**Central Gate  
Home Improvement**

TO: HENRY SCHEIBLE, CHAIRMAN PLANNING BOARD  
FROM: MARK J. EDSALL, P.E., PLANNING BOARD ENGINEER  
SUBJECT: CENTRAL GATE SITE PLAN (T87-58);  
TOWN OF NEW WINDSOR, N.Y.  
DATE: 22 June 1988

TOWN OF NEW WINDSOR  
PLANNING BOARD  
REVIEW COMMENTS

TO: New Windsor Planning Board  
FROM: Town Fire Inspector  
DATE: 5 May 1988  
SUBJECT: Central Gate Home Improvements  
PB-87-58 FB-88-25  
88-06 Disapproval

SITE PLAN  
SCALE: 1/8" = 1'-0"

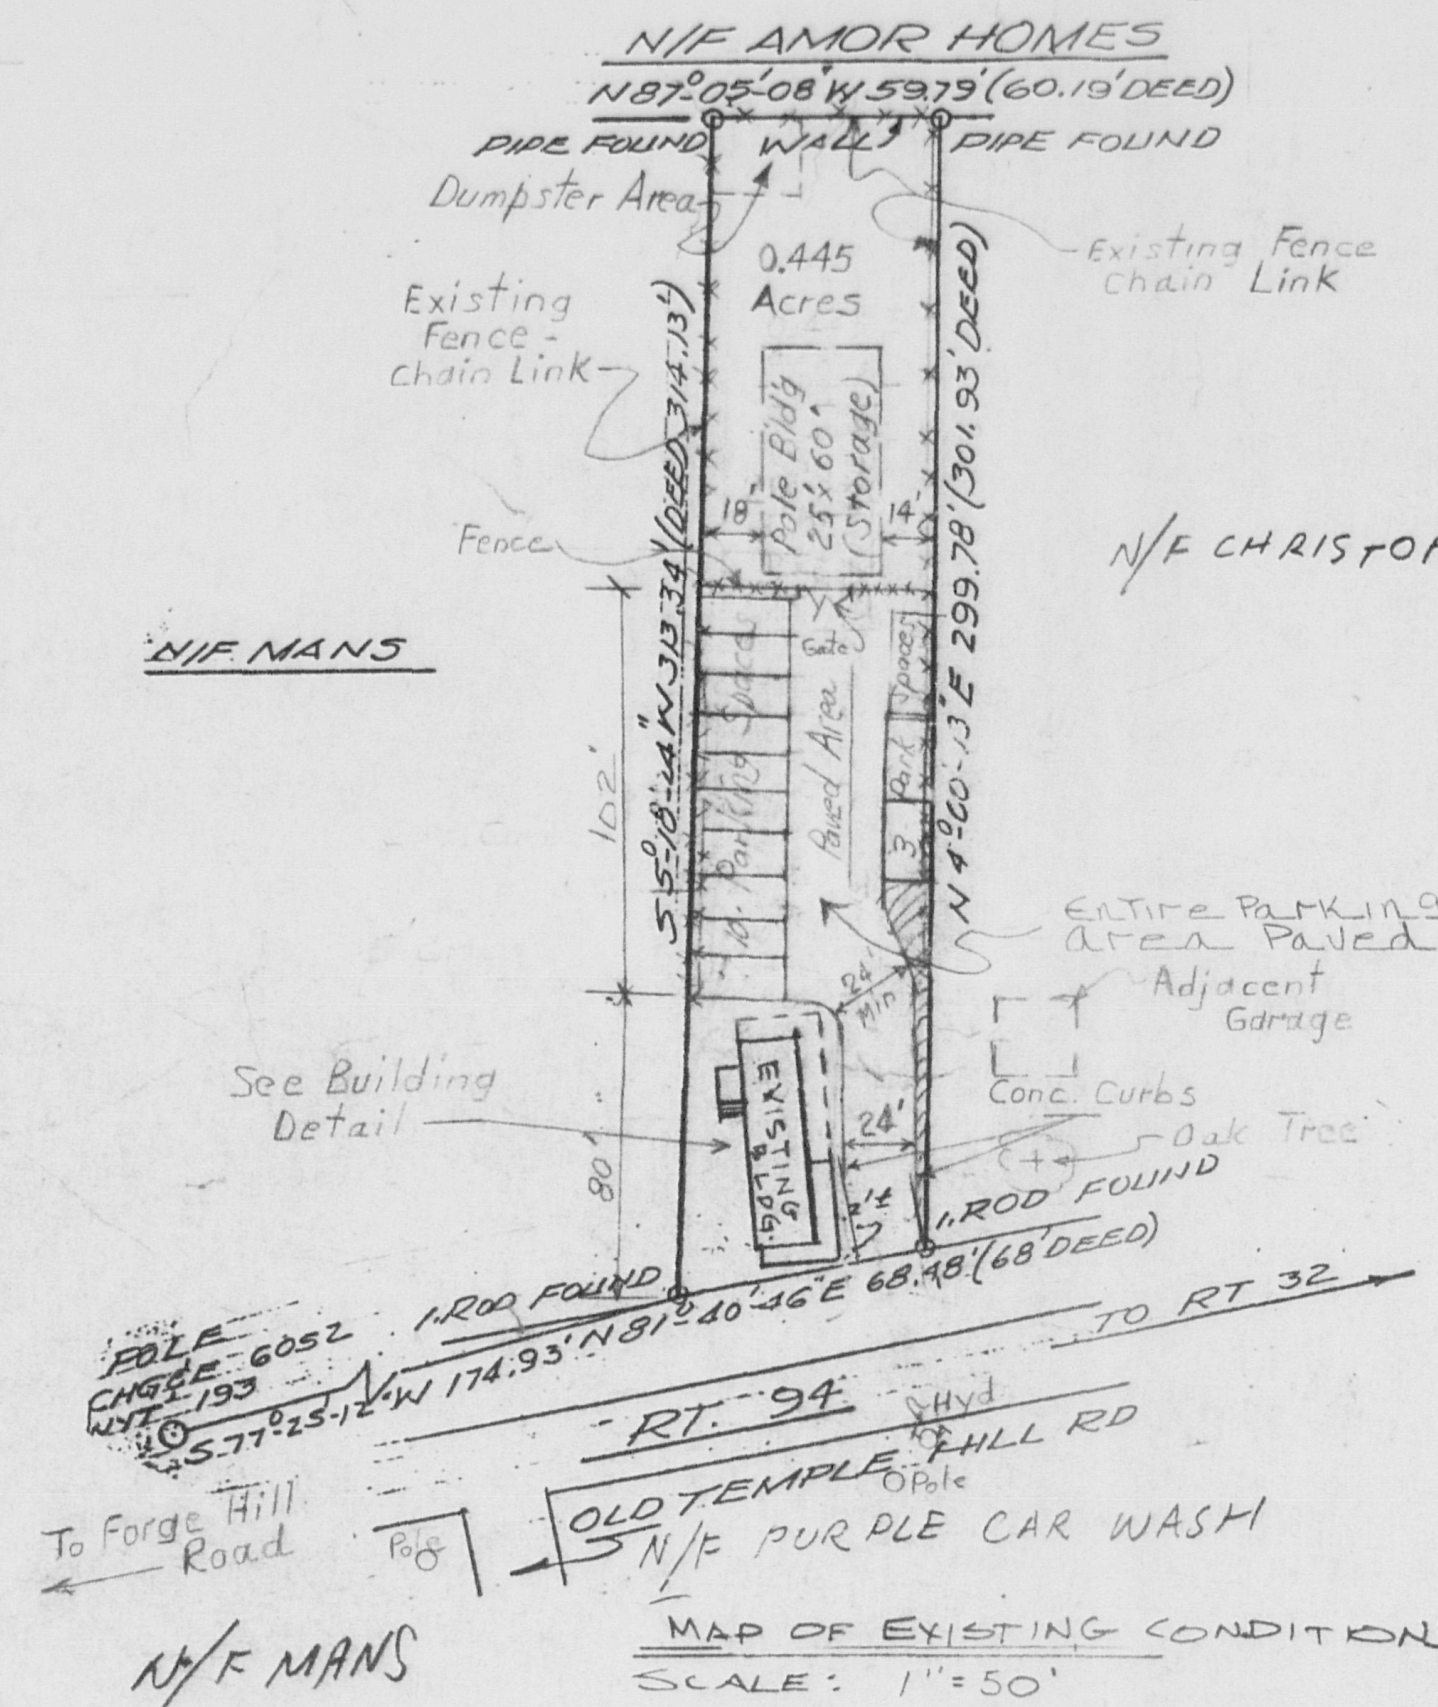
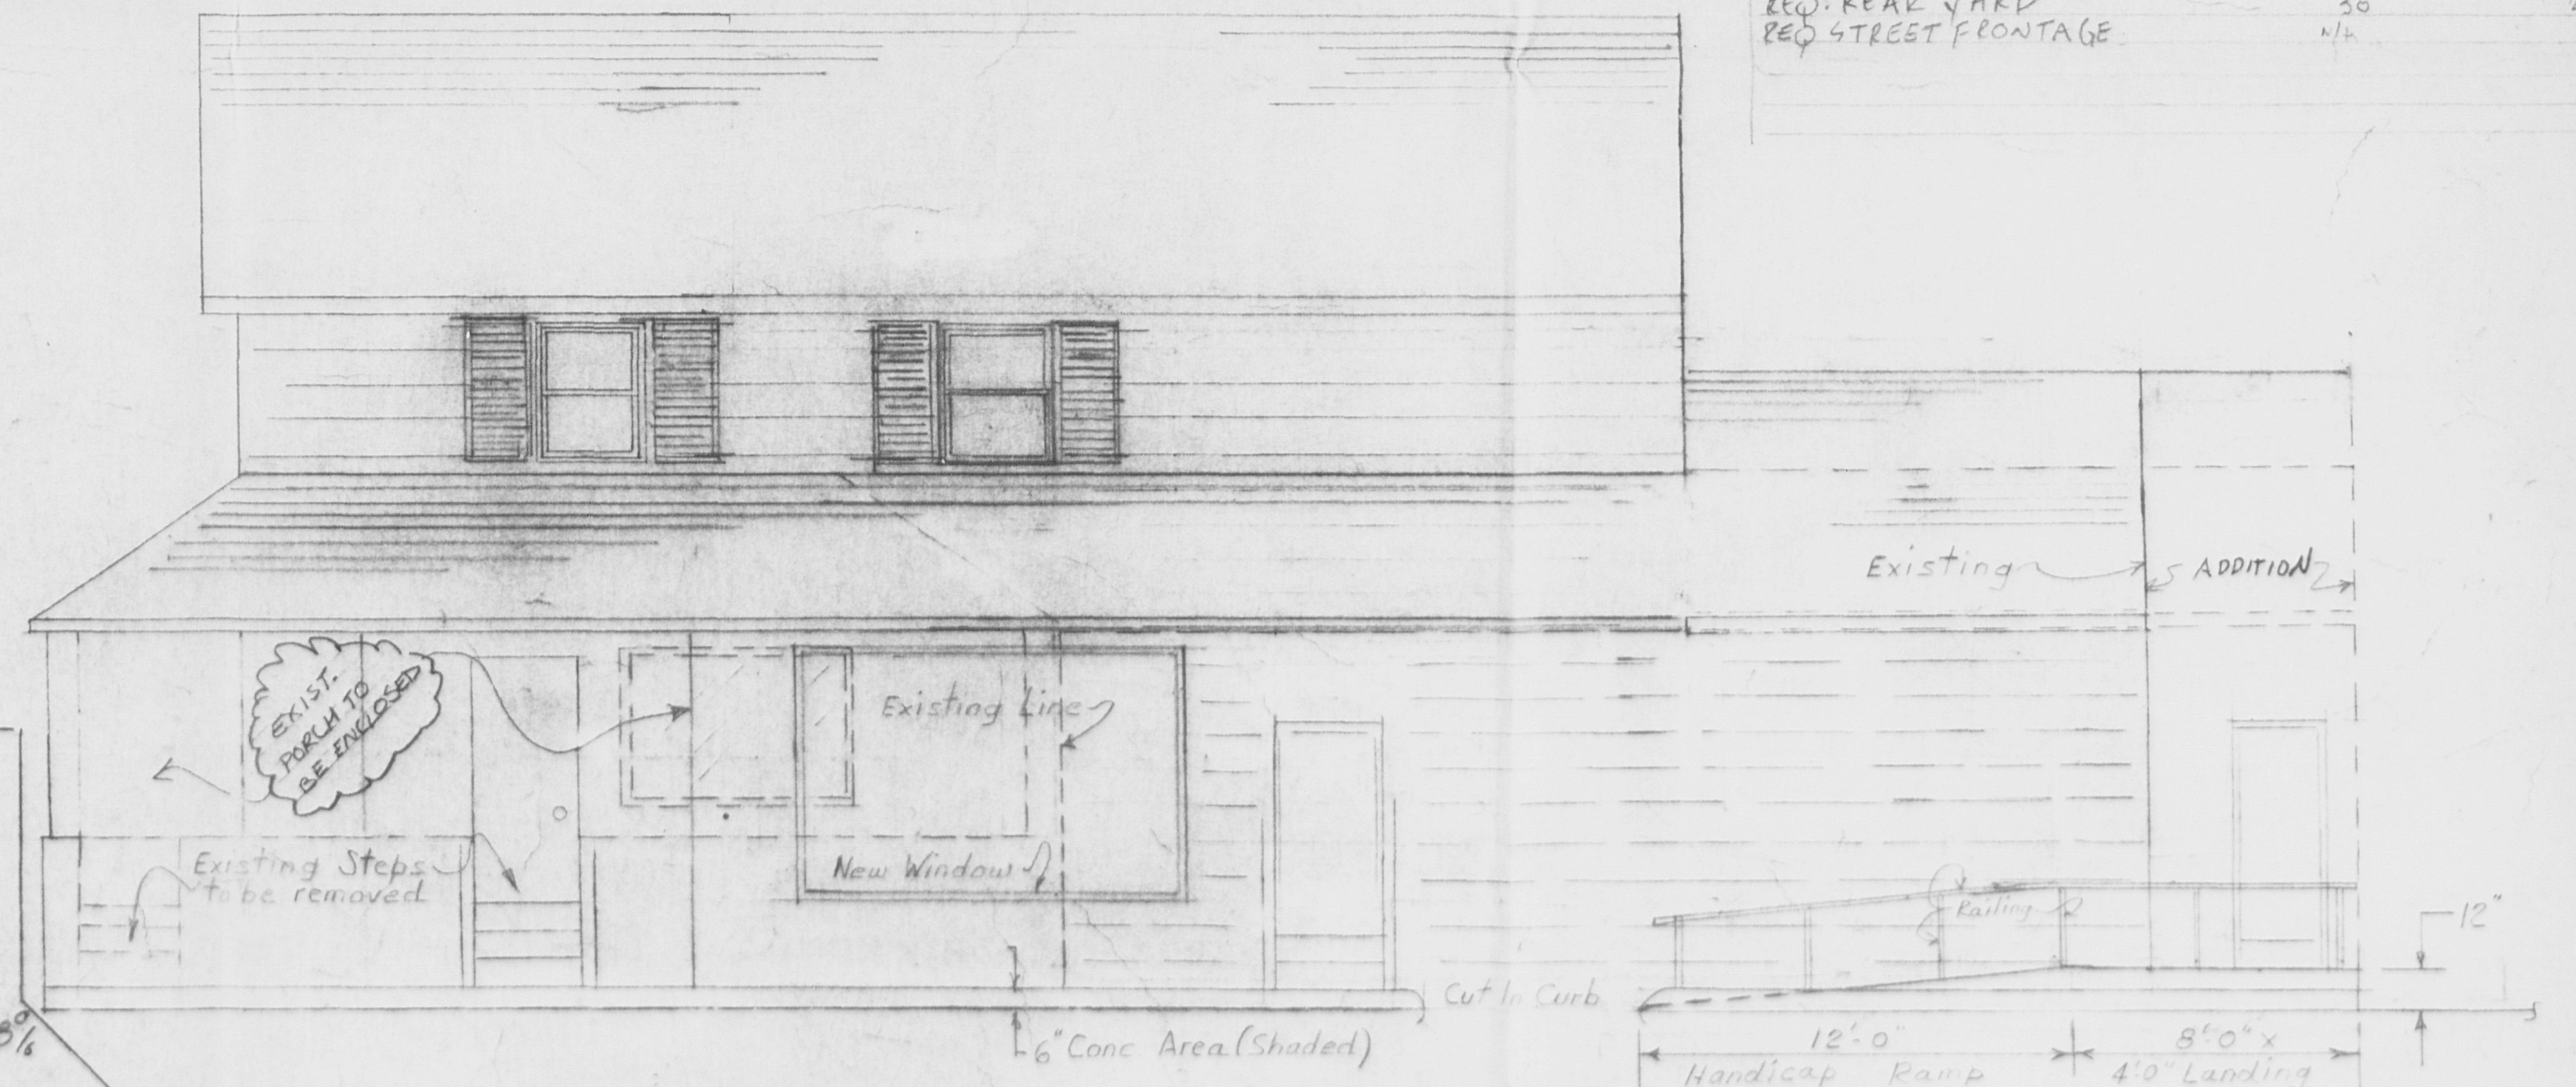
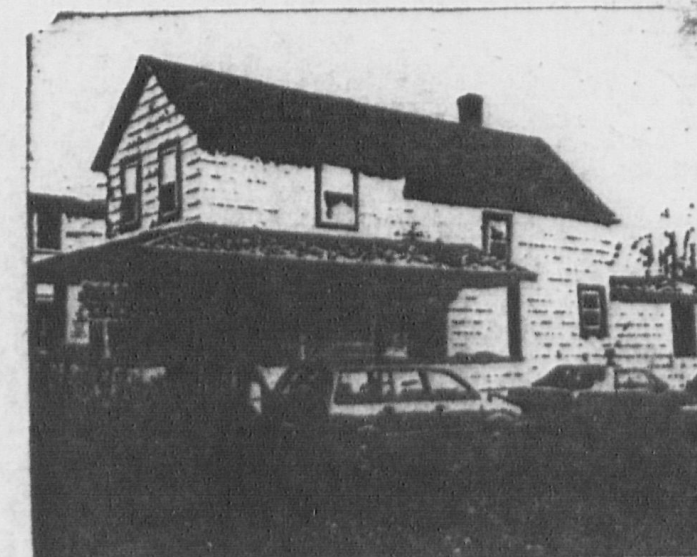
1. The plan indicates a total of ten (10) parking spaces are required; however, only six (6) of the ten (10) spaces are on the "outside" of the fenced area. It was my understanding that the applicant would have all ten (10) spaces "outside" of the fenced area.
2. The plan was to indicate that the entire parking area would be paved. This is not clearly indicated.
3. It was requested that the plans show a handicapped parking sign; same is not shown.
4. The plan indicates striped areas along the west side of the building and west side of the property. Is this a grass area, striped paved area or what? The plan does not give any indication.

2. The plan has been reviewed to indicate dimensions which would comply with certain comments provided by the Planning Board and Fire Prevention Bureau. A review of the plan brings to light several inconsistencies between the scaled dimensions and indicated dimensions. Some examples are as follows:

- a. The driveway width is indicated as 24' and in both cases scales 20'.
- b. On the site plan, the location of the third building entrance from the front (on the west) scales 27' from the rear building wall, on the side elevation same scales 24 1/2'.
- c. On the side elevation, the length of the handicapped ramp is indicated as 18' and same scales 17'.

Inasmuch as this is an existing structure and existing site, I question these dimensions as indicated above. If the existing dimensions are such that installation of the ramp to a length as necessary to comply with State Building Code and ANSI requirements cannot be made, this should be determined prior to Planning Board Approval. In similiar fashion, it should be determined whether there is actually enough room for a 24' drive as shown on the Plan. These existing dimensions must be verified and accurately indicated on the

3. The location of the handicapped parking space and the affect of the fence on access to the various parking spaces should be further discussed.

- 1) The eight (8) foot gate opening is not sufficient in width for a fire apparatus to pass through. (Minimum of twelve (12) foot gate opening needed.)
- 2) If gate is opened, the handicapped parking space would be unavailable for use by the handicapped. Gate to be relocated or move the handicapped parking space to another location.
- 3) No railing is shown for the handicapped ramp or handrail on building. (see attachment "A")
- 4) The four (4) X four (4) concrete slab at top of ramp does not appear to comply with ANSI specification. (see attachment "B")

Mr. Edsall: Looking at the side elevation on the right shows four foot landing outside the door. The code requires an additional two foot of flat area before you start the incline of the ramp. I didn't get the plan that was updated until after the reviews were done. If you add the two foot on and then properly scale the eighteen feet, the ramp is into the next staircase which I don't believe meets code.
